KANE COUNTY

STORMWATER MANAGEMENT TECHNICAL ADVISORY COMMITTEE

APRIL 25, 2018

Continued Buffers, Best Management Practices & Sediment Erosion Control

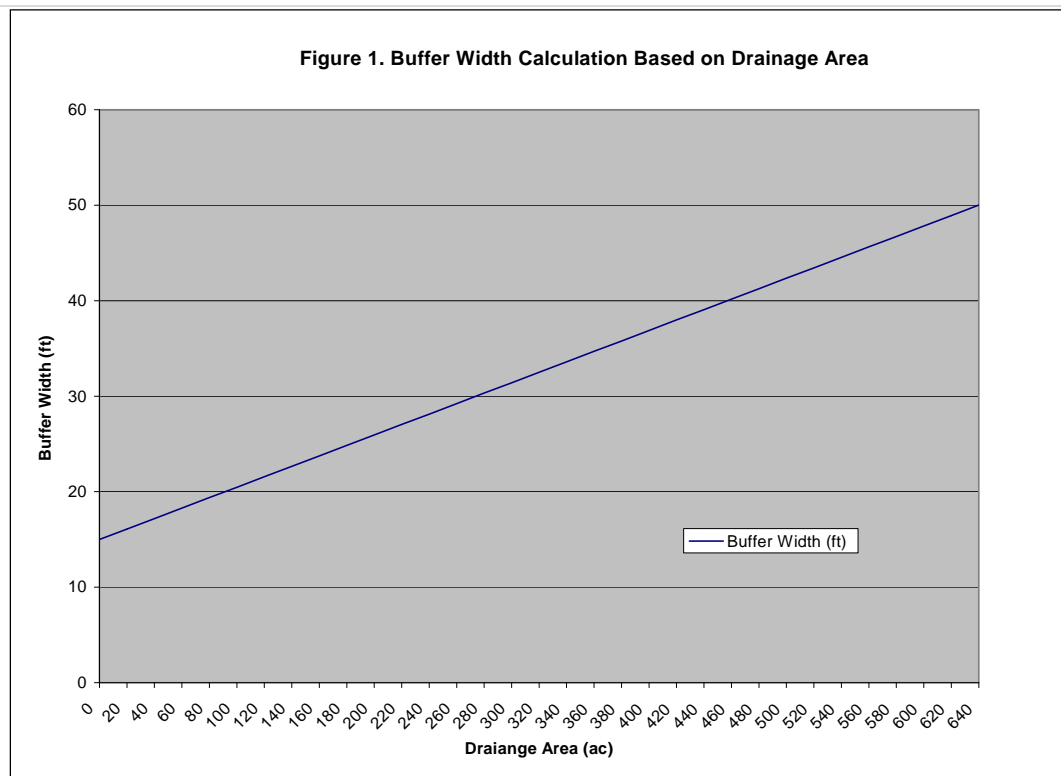
Background: The current standard allows path up to 10' wide. Consider allowing paths up to 14' wide. This is the widest path requirement per the latest version of AASHTO Guide for Development of Bicycle Facilities.

Suggested Change: A buffer area may be used for passive recreation (e.g., birdwatching, walking, jogging, bicycling, horseback riding and picnicking) and it may contain pedestrian, bicycle or equestrian trails, provided that the created path is no wider than fourteen feet (14'). If the path leads to a wetland, it must be a winding path to help prevent erosion.

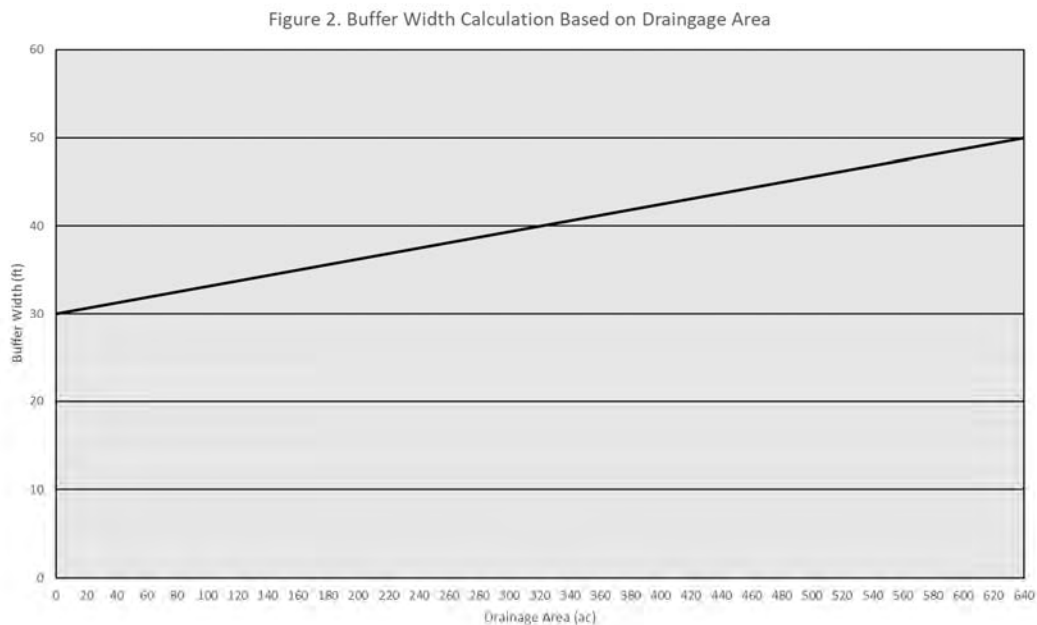
2. When the lineal waters of the U.S. have a drainage area less than six hundred forty (640) acres, measured at the downstream property line, the buffer width shall be determined utilizing the formula, $X = (A * 0.0547) + 15$, where "X" equals the buffer width in feet and "A" equals the drainage area in acres. The width calculated by this formula shall be rounded up to the nearest multiple of five (5). Figure 1 of this section may be used to determine buffer widths provided the resultant width is increased to the nearest multiple of five (5)." The current Table is below in Figure 1.

Research (see attached) indicates that the buffer width for nutrient retention should be between 5-30 meters (16.4-98 feet); while the effective buffer width for protection of aquatic wildlife and stream temperature is between 10-30 meters (33-98 feet).

Research indicates that buffering low order streams has greater positive influence on water quality than wider buffers on portions of larger order streams already carrying polluted water. Failure to protect to the smaller headwater streams ignores important sources of

sedimentation and pollution. The USACE requires a 50-foot buffer for Waters of the U.S. and most other collar counties require between 30 and 50 feet.

Suggested Change: We recommend increasing the minimum buffer of 15 feet to at least 30 feet for linear water bodies with less than 640 acres of tributary area. If 30 feet is the desired width the new equation would be:

$X = (A * 0.03125) + 30$. See revised Table Below in Figure 2:
